INLAND FISHERIES AND WILDLIFE NATURE PARK - ADDENDUM #1

date: May 13, 2024
project: Inland Fisheries and Wildlife Store and Admin Office Project # 3096
prepared by: Ryan Kanteres Simons Architects
Adam Wiles-Rosell Simons Architects
Mikayla Molta Simons Architects

Subject: **Addendum #1** to Bid Documents of April 23, 2024

A420

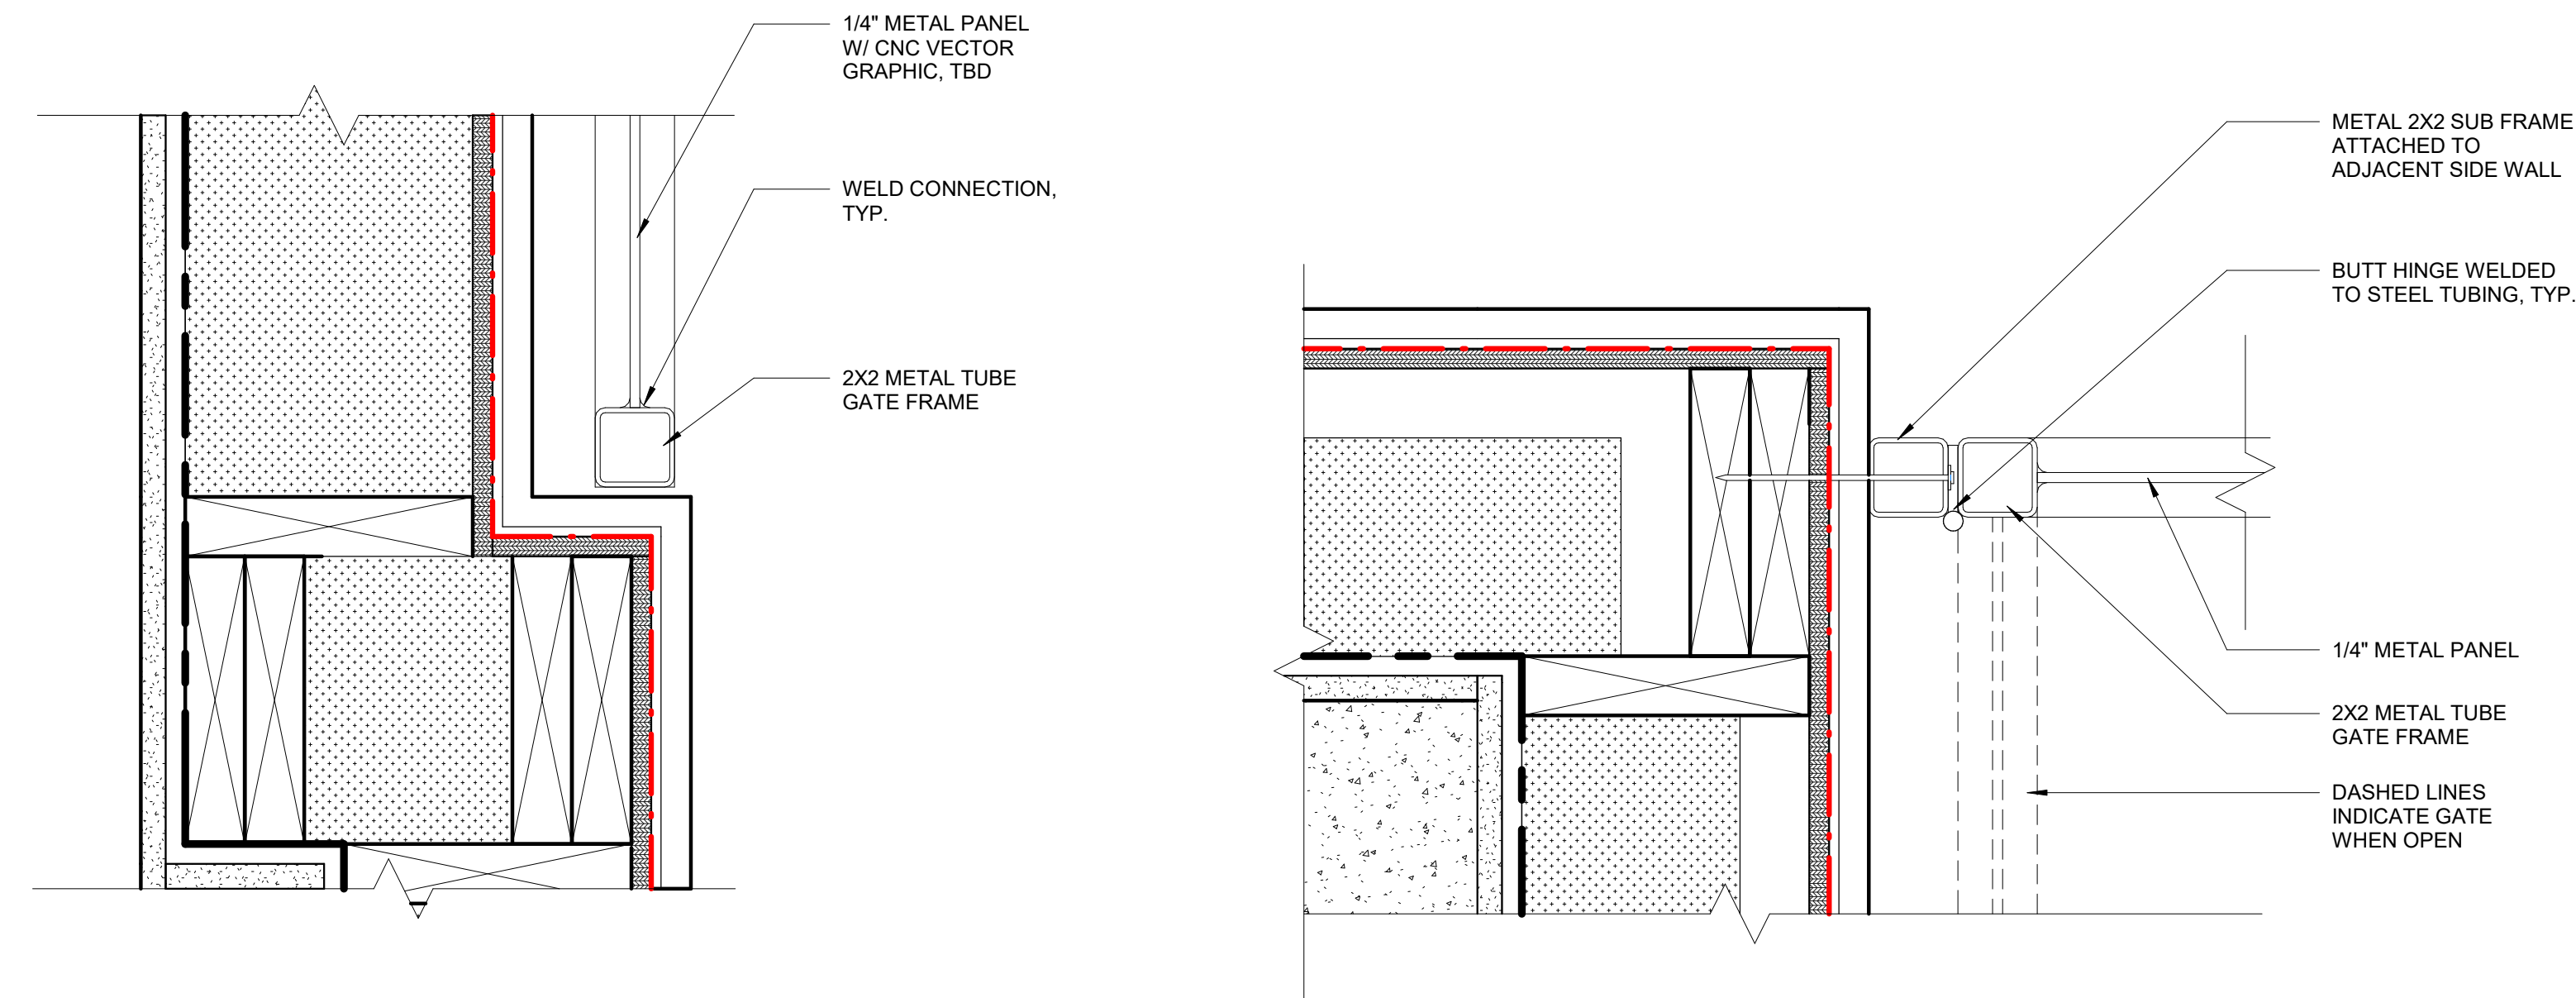
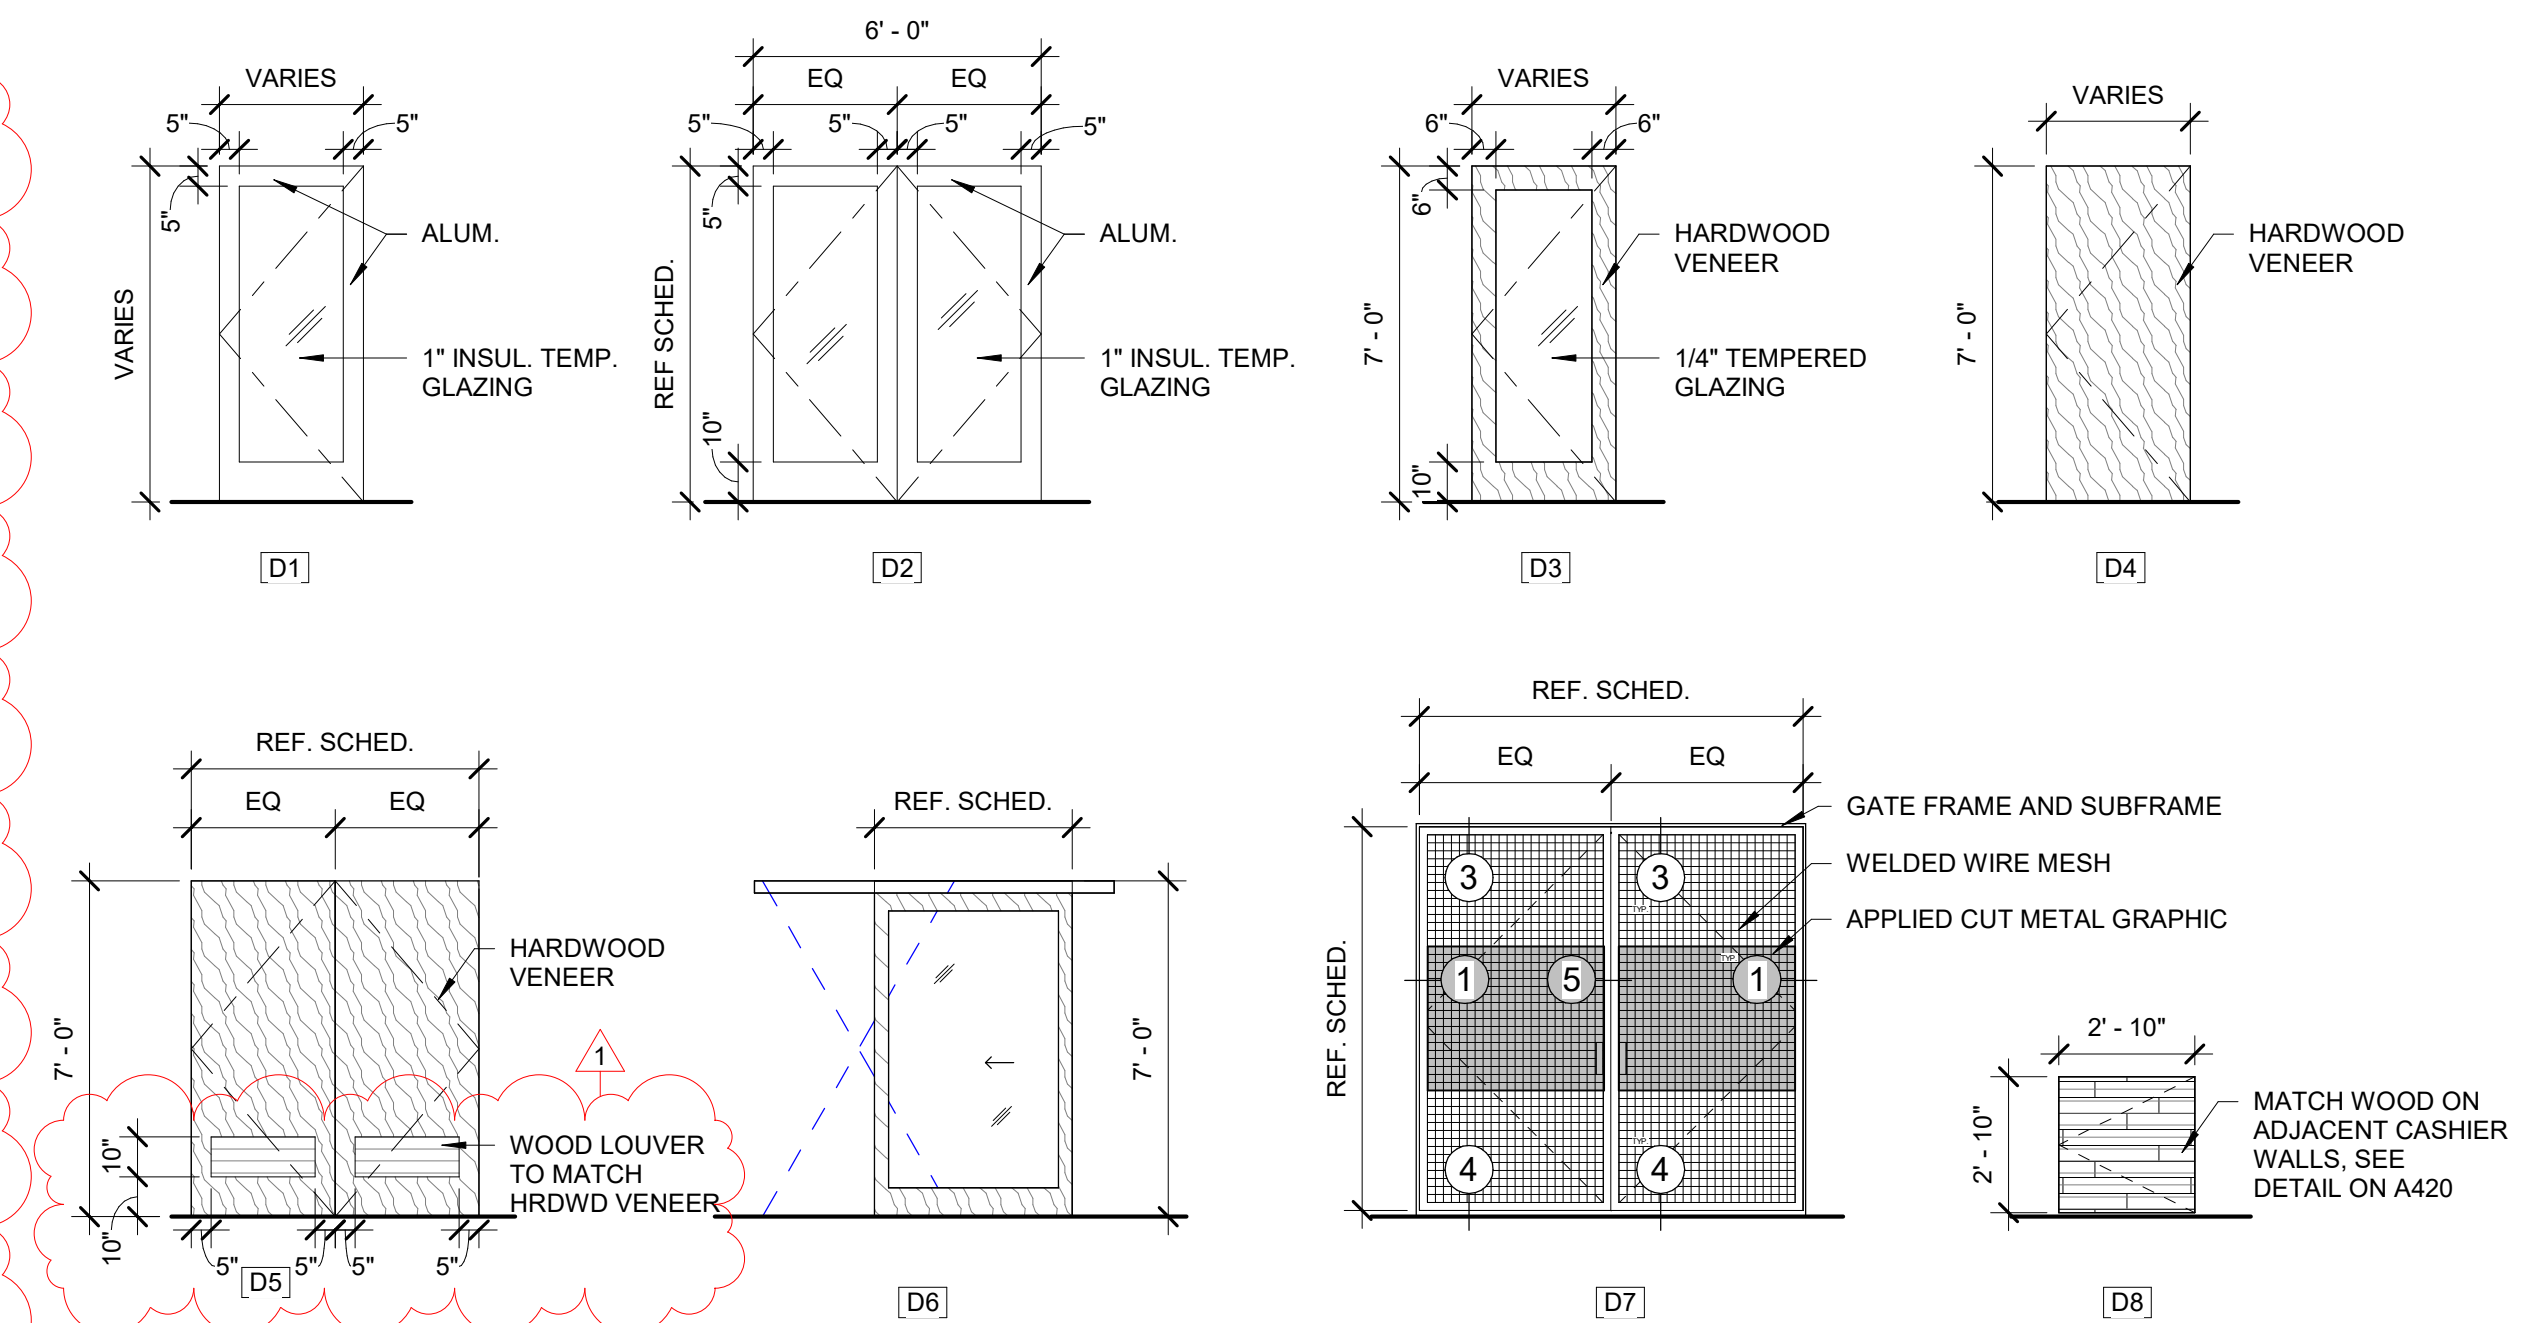
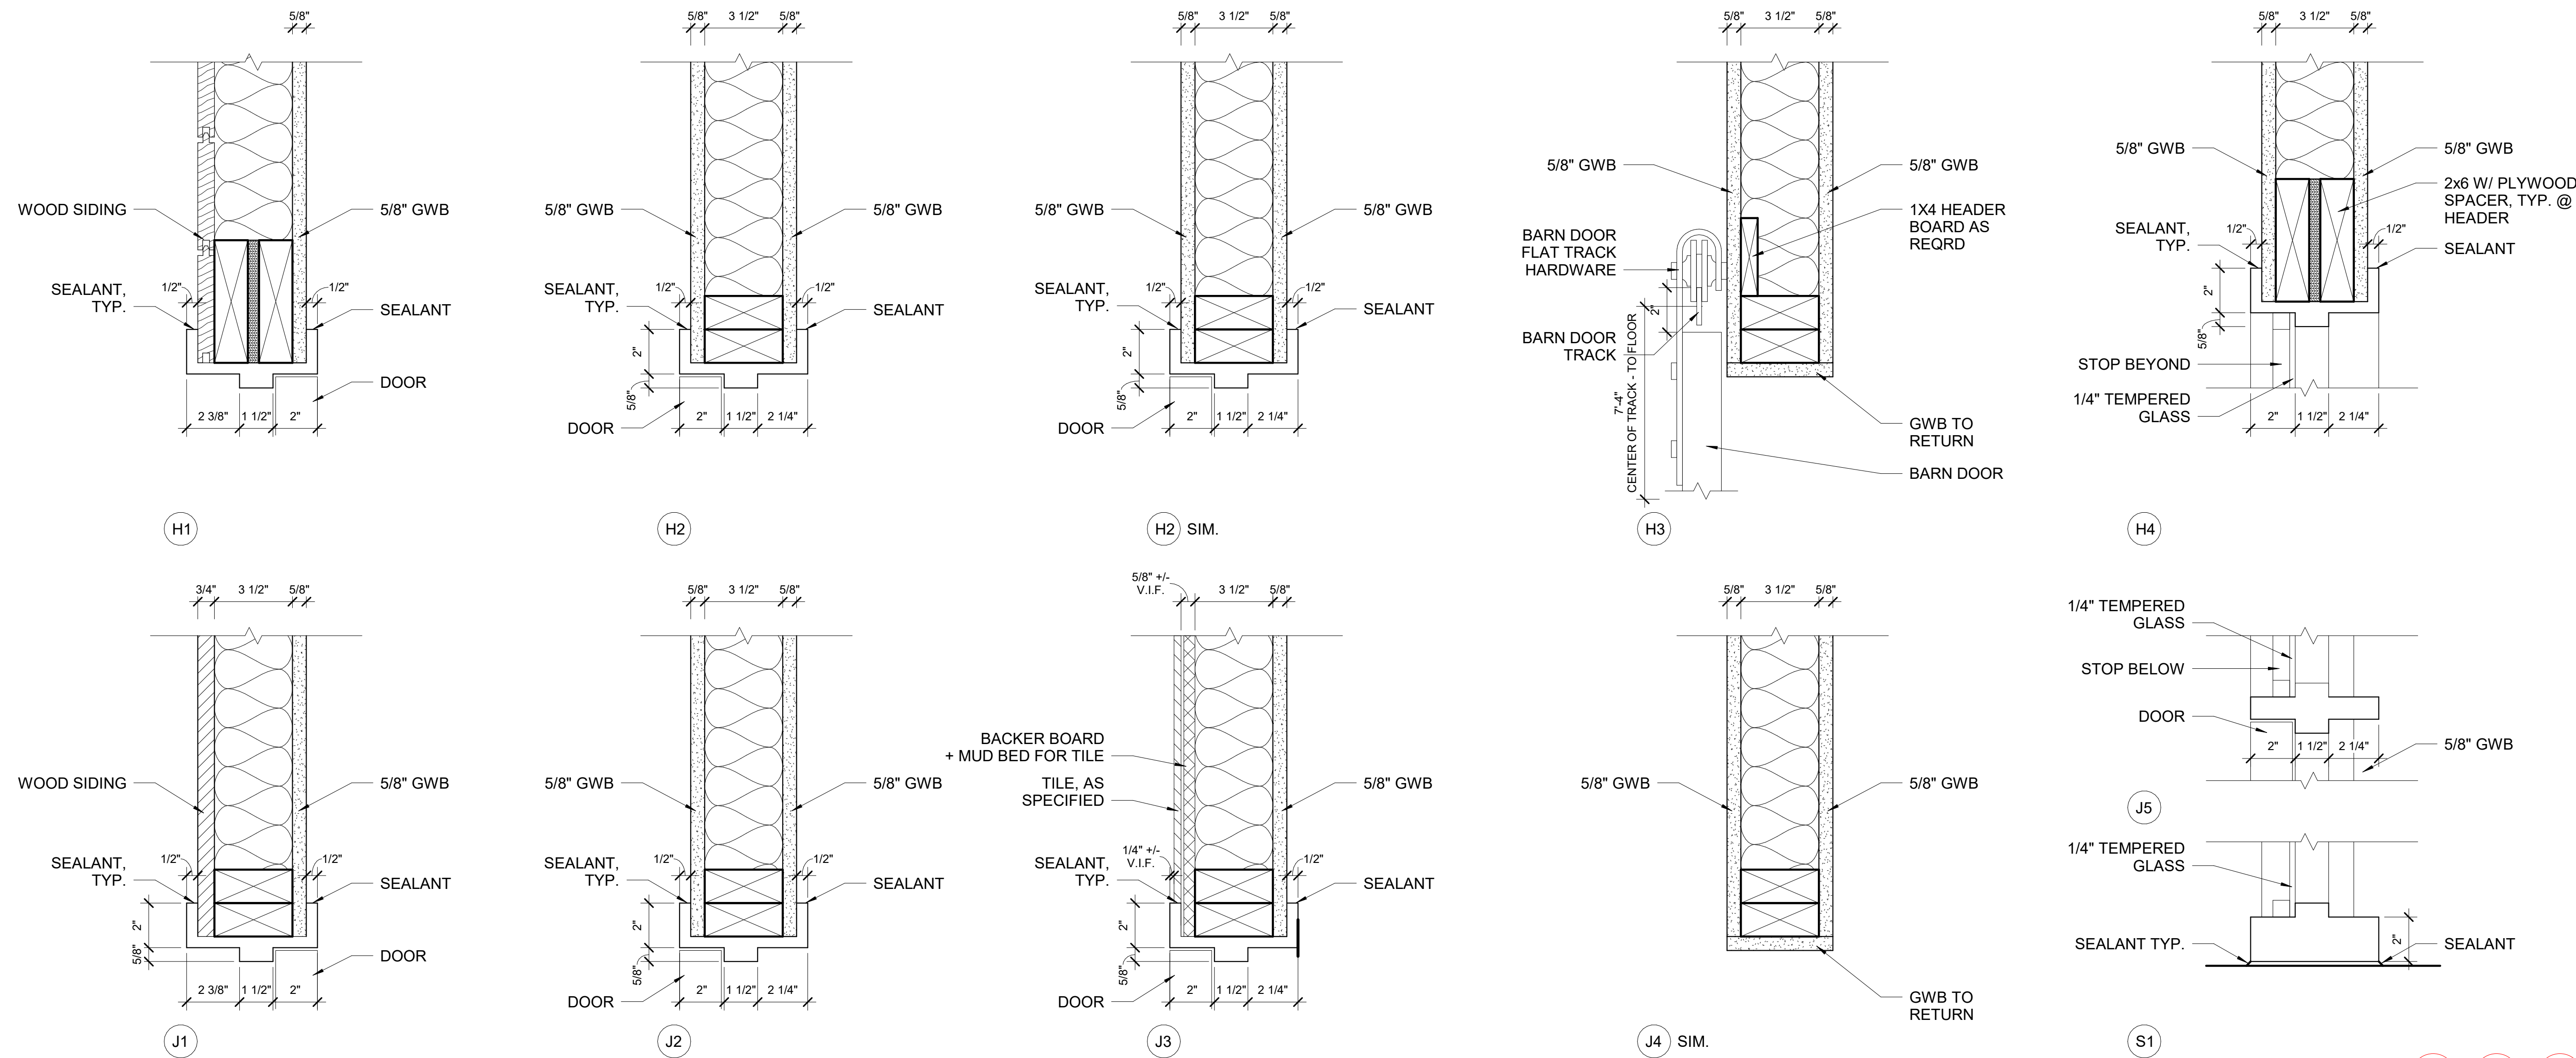
- 1-D21 Sheet A420 Detail 3 sheathing coordinated with A000 wall assemblies to reflect sheathing sizes. Detail 3 and 4 adjusted to include flush base nosing + framing to boot storage detail. Coordinated data closet needs with D5, wood louver added to door panel.

S202

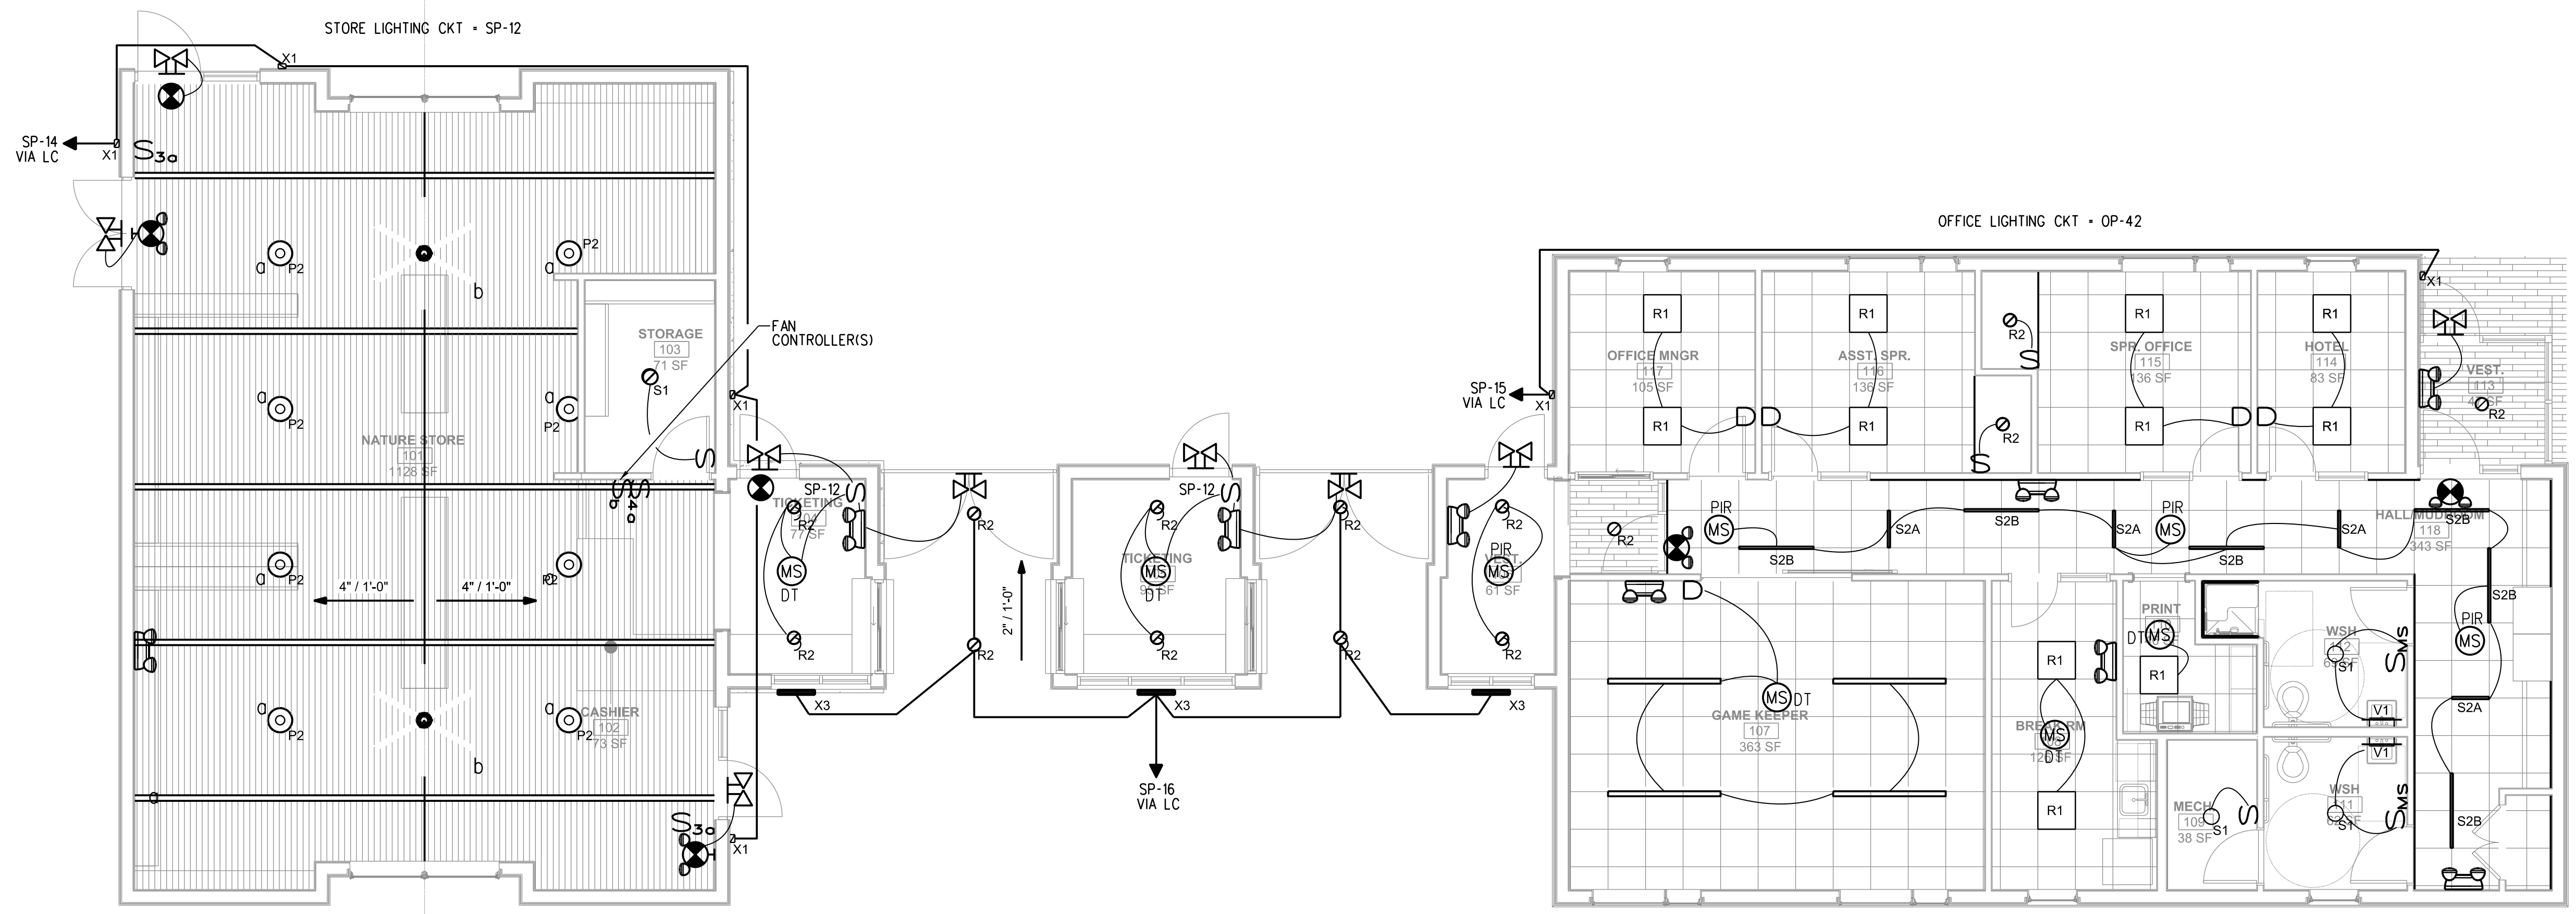
- 1-D29 Sheet S202 5/S202 Truss dimension clarified. Rebar schedule and typical details provided.
- 1-D30 Sheet E101 Lighting schedule updated.
- 1-D31 Sheet E201 See revised mechanical room and tel/data closet layout. See notes on EC provided conduit runs vs. utility conduit runs provided by others. See plan for revised data receptacle locations and WAP locations. See ADA door push pad and operator revised location.
